MFN 06-191  
Supplement 2

Subject: **Response to Portion of RAI Letter No. 38 Related to ESBWR Design Certification Application - Seismic Category I Structures - RAI Numbers 3.8-3, 3.8-13, 3.8-25, 3.8-41, 3.8-48, 3.8-51, 3.8-64, and 3.8-91- Supplement 2**

**MFN 06-191, SUPPLEMENT 2**

**Seismic Category I Structures**

Figure 3.8-3 (1)

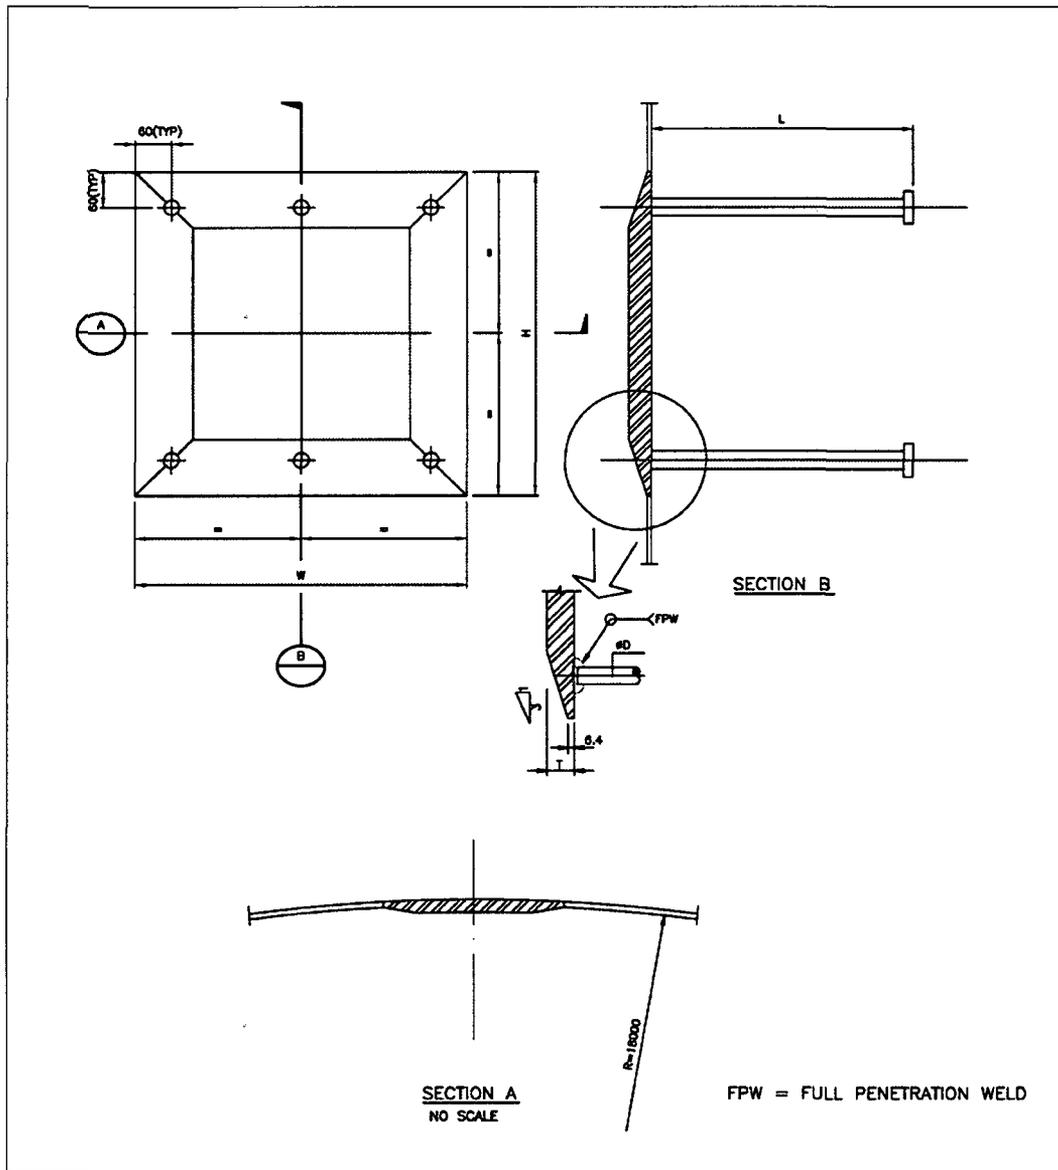
- a) *Describe embedded plates to support steel members inside containment and show sketch of interaction with liner plate.*
- b) *Describe embedded plate support steel members (from pipe whip restraints; piping supports; etc) outside containment and show sketches with anchors into concrete containment.*
- c) *Describe diaphragm connection to containment and reference DCD figures as appropriate. Indicate whether fixed ended or simply supported and type of weld to be used (FP;FW; etc)*
- d) *Provide description and sketch of a typical embedded plate outside containment that supports commodity items like ducts, trays, conduits, etc.*

- a) Regarding steel members such as structural steel shapes, piping supports or commodity supports inside containment, Figure 3.8-3 (1) below shows a typical support plate with anchors embedded in the concrete containment. The dimensions of the plate and the number of anchors depend on the loads for each support. They are designed in accordance with ANSI/AISC N690 and ACI 349 Appendix B.

**Figure 3.8-3 (3) - Refueling seal: Comparison of compressed and extended bellows.**

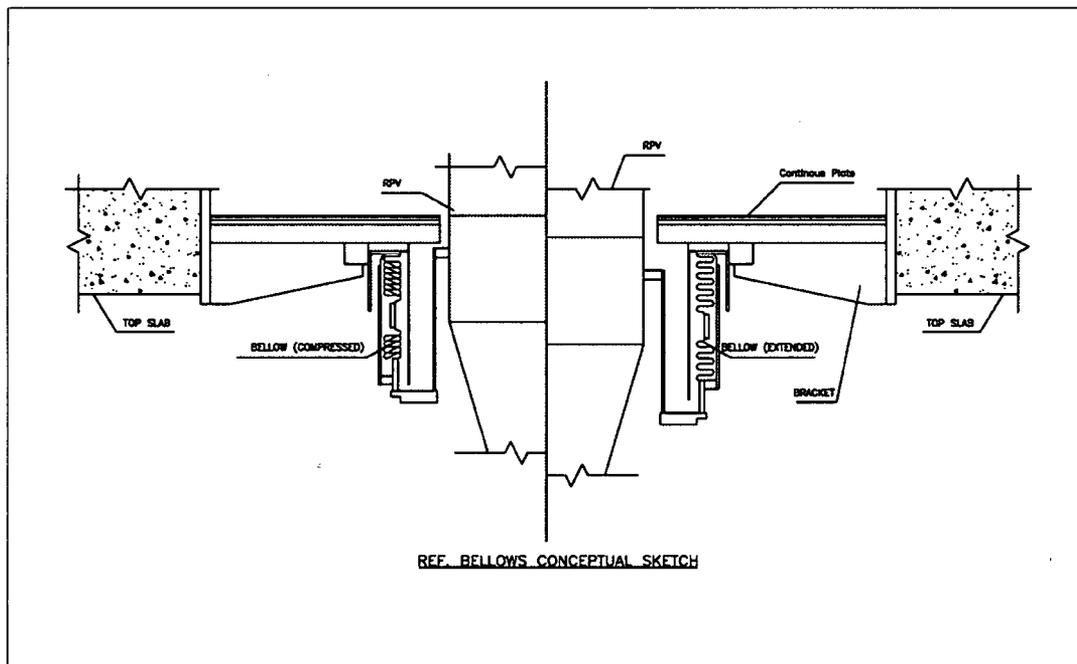
- a. *Provide conceptual design detail of RPV stabilizer.*
- b. *Provide conceptual design detail of Refueling Seal.*

- a. See RAI 3.7-27, Supplement 1.
- b. See Fig. 3.8-3 (3) for conceptual design details of the Refueling Seal.

Figure 3.8-13 (1) Comparison of Basemat Deformation for Dead Load

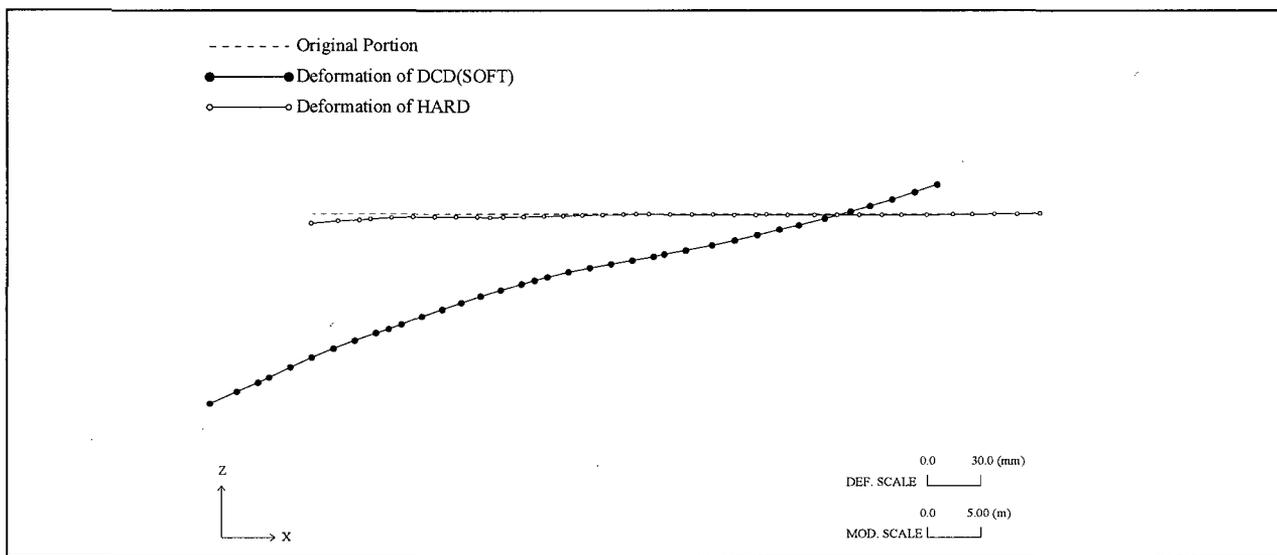
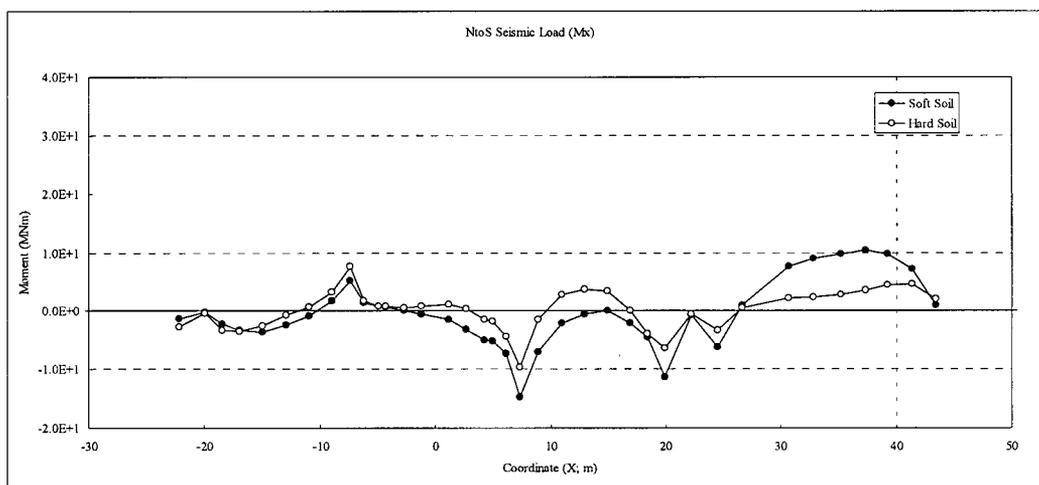
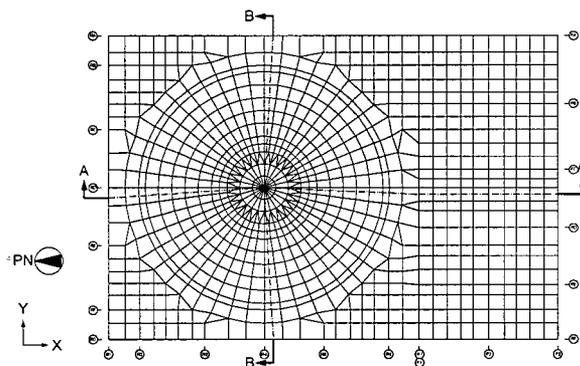
- a) *The part (a) response needs clarification and possible revision of the DCD to describe/explain how the dynamic stick model results for multiple soil cases were used to develop the statically applied seismic loads used in the NASTRAN model. How was conservatism verified?*

*It was shown that under load combination of DL+LOCA+SSE there is a small uplift on the south side of the mat. This means that the soil springs in this area are in tension, which is not possible. GE needs to re-run this analysis without the soil springs in this area taking uplift and demonstrate that this effect is not significant. Cut end springs to check uplift effects at end of mat for soft and hard soil conditions.*

Figure 3.8-13 (1) shows the sectional deformations of the basemat. Figures 3.8-13 (2) and (3) compare the bending moments generated in the basemat. Basemat deformation for the soft soil condition is much larger than that of the hard rock condition. As for bending moments, their magnitudes for the soft soil are larger than those for the hard rock, in general. The higher bending moments at few locations for the hard rock site has no impact on the design since they are much less than the maximum moments of the soft soil site on which rebar sizing is based.

(Note that there is a small uplift on the south side of the basemat under the soft soil condition.)

Figure 3.8-13 (6) Comparison of Basemat Deformation without Tension Springs

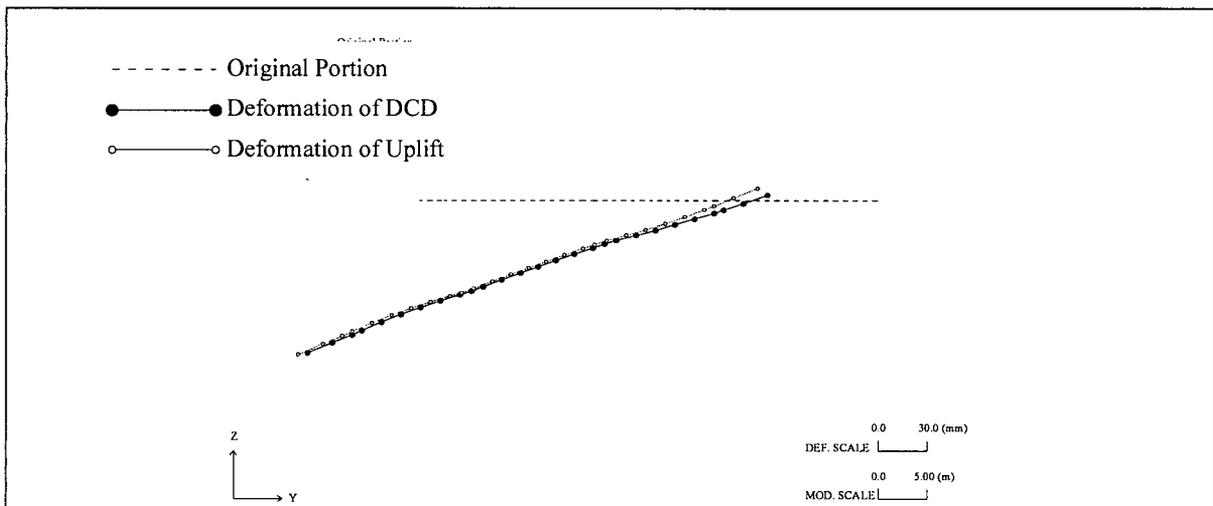
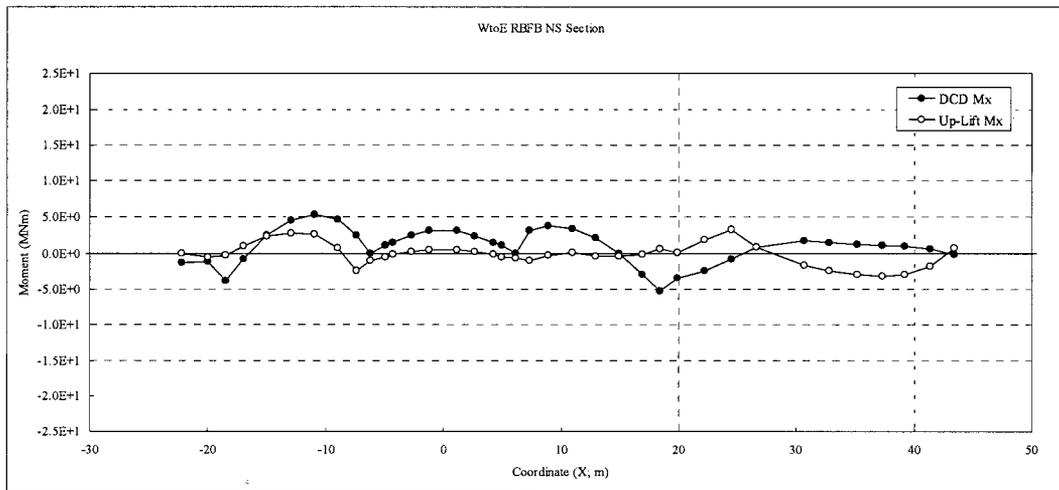
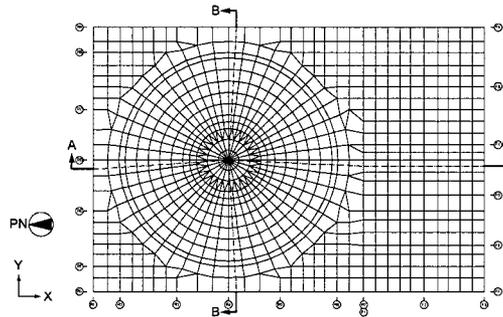
*Supplement 1 showed only seismic loading in N-S direction. Provide results for seismic loading in 3 directions.*

Figures 3.8-13 (6), (7) and (8) show the comparison of the sectional deformations of the basemat and bending moments generated in the basemat respectively at the final step of iteration. In the area close to the cylindrical wall below the RCCV wall, bending moments are higher than that of DCD design; however the resulting stresses in the concrete and reinforcement are still below the code allowables with large margins as shown in Table 3.8-13 (4). Stress calculations in Table 3.8-13 (4) were performed for the following combinations to consider the effects of three directional inputs:

Figure 3.8-25 (1) Rigid Bar Elements between Concrete and Liner

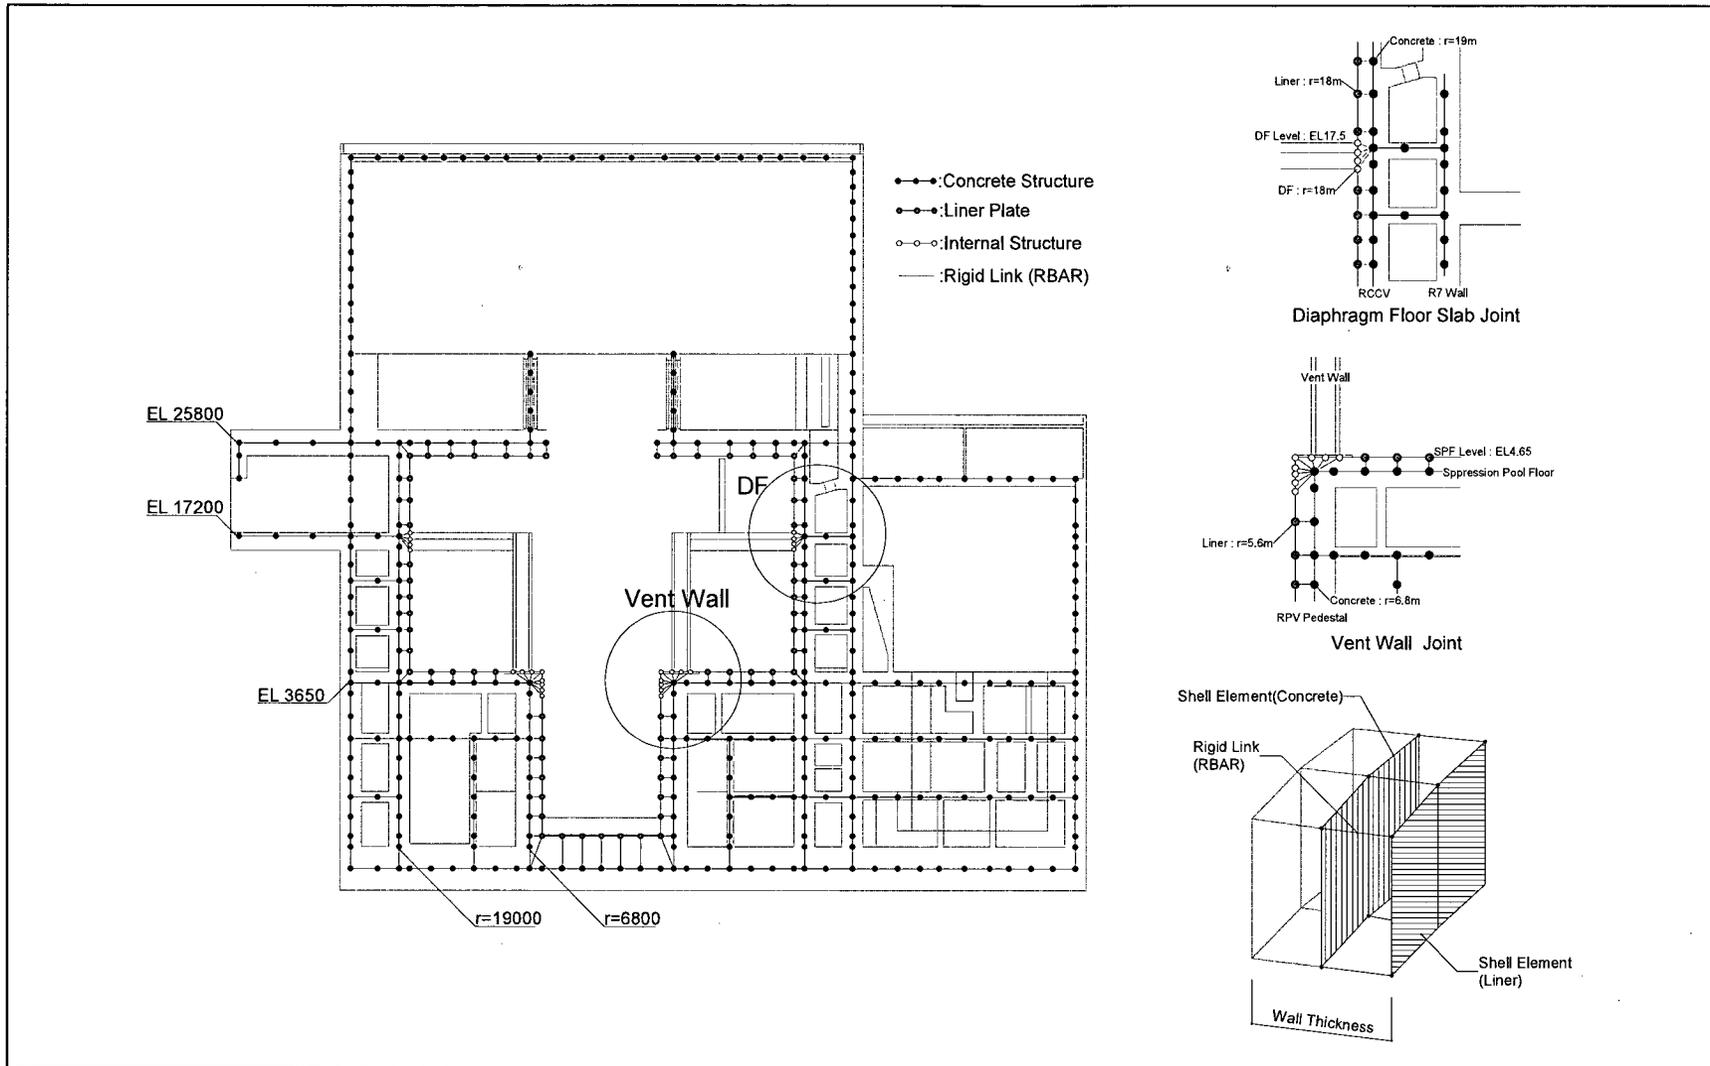
*Describe how the analysis of a typical liner plate-to-RCCV attachment is performed using the NASTRAN model results. Include this information in DCD Section 3.8.1 and/or Appendix 3G.*

Rigid bar elements connect the corresponding grid points of the liner elements and concrete elements as described in DCD Appendix 3G.1.4.1. They are schematically shown in Figure 3.8-25 (1). To represent the anchor, rigid bar elements are placed in the radial direction for the liners of the RCCV cylinder wall and the RPV pedestal. They are placed vertically for the basemat, the suppression pool slab, and the top slab.

Figure 3.8-25 (2) Analysis Models

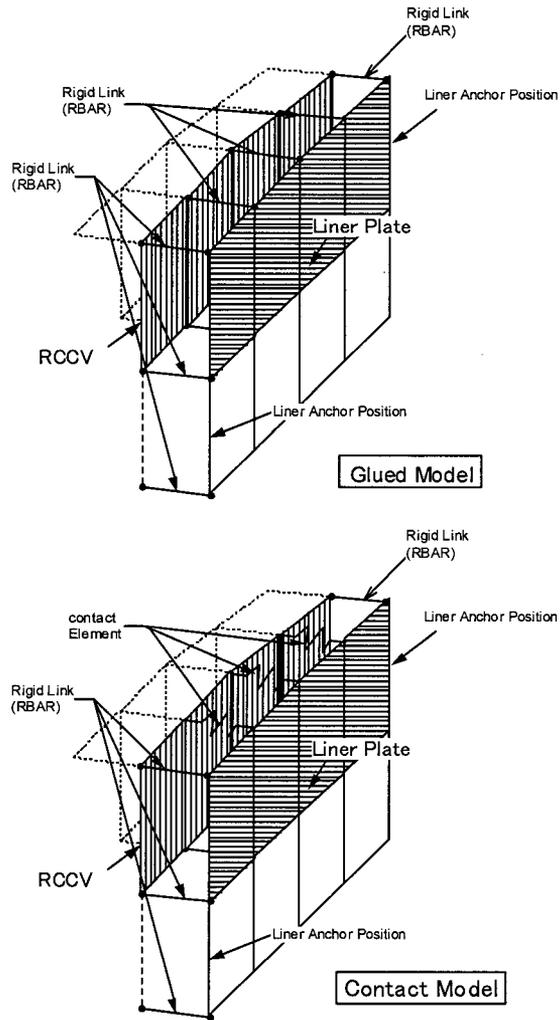
*Evaluate the concerns identified at structural audit in July 2006 related to the potential for the liner to penetrate the concrete surface, and the liner grid spacing versus the actual spacing, and also explain how the forces on the anchors are determined if 1/10,000 E is used for the liner in the NASTRAN model.*

The width of the model is twice the Liner anchor pitch (2 x 5.14 degrees) and the height is the half of width. Six degrees of freedom of nodes provided for liner are subordinations to these of RC wall. Figure 3.8-25 (2) shows the analysis models.

Figure 3.8-64 (1) Displacement of FB Frame Members due to Horizontal Seismic Load

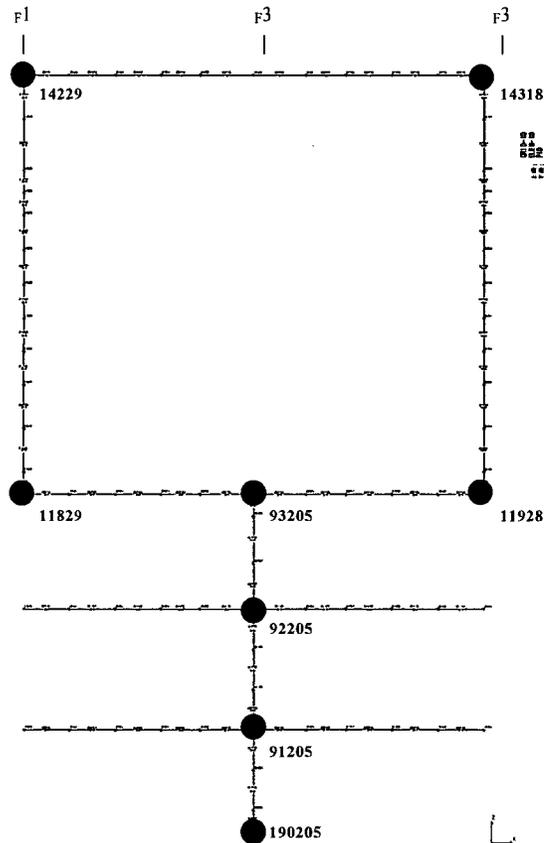
- a) *GE to include supplemental response given at the audit in this RAI response. GE needs to strengthen the response regarding why deformations for design loads are not strictly performed. Need to characterize the term “not so large” and broaden the response to address all frame members.*
- b) *Clarify RAI response as follows:*
- *Add a subsection to DCD under 3.8.4.5 describing the EBAS building.*
  - *Add note stating that Column deflection does not control the design.*

- a) Supplemental response is provided below regarding frame members and deformation under design loads:

For concrete frame members, it is confirmed that their thicknesses satisfy the requirement for the minimum thickness specified in ACI 349-01, Section 9.5.1.1, Table 9.5 (b) for deflection control.
